SERVICE BULLETIN

CHANGE OF COOLANT SPECIFICATION ON ROTAX® ENGINE TYPE 912 AND 914 (SERIES)

SB-912-043
SB-914-029

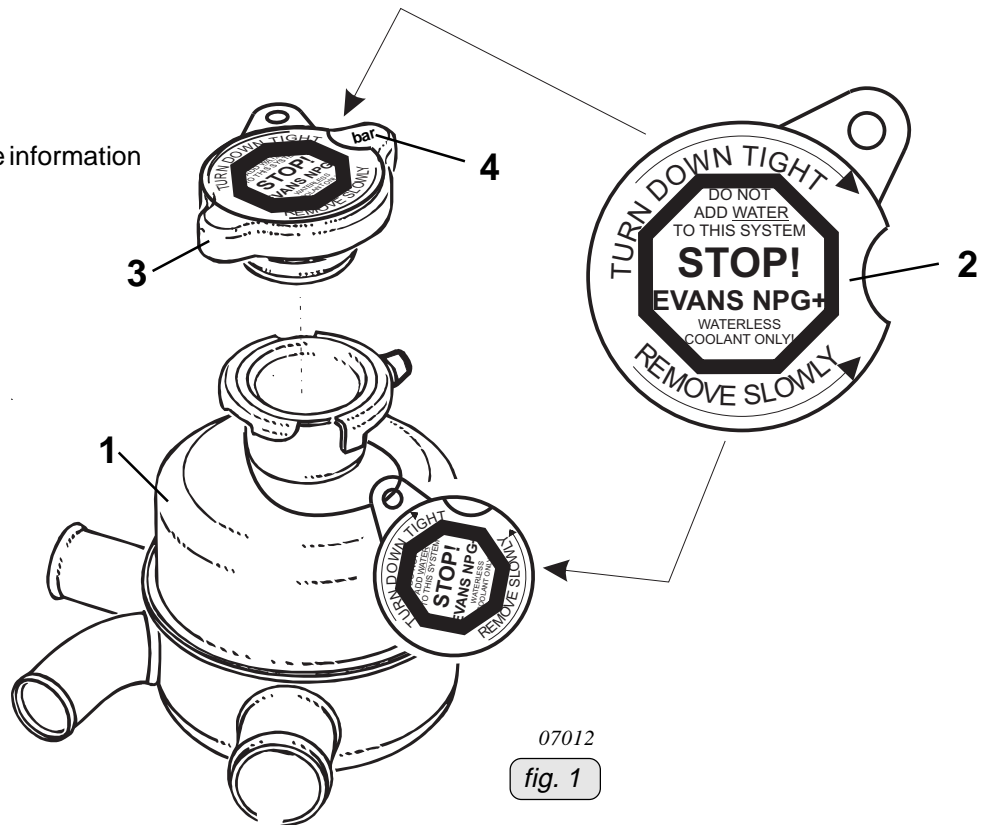
◆ **NOTE:** On the radiator cap (3), to identify the new coolant, the warning label (2) is to be affixed so that the opening pressure data (4) is visible.

- For new engine deliveries the sticker will be temporarily attached to the expansion tank.
- The sticker has to be affixed to the radiator cap in accordance to the aircraft manufacturer's instruction.
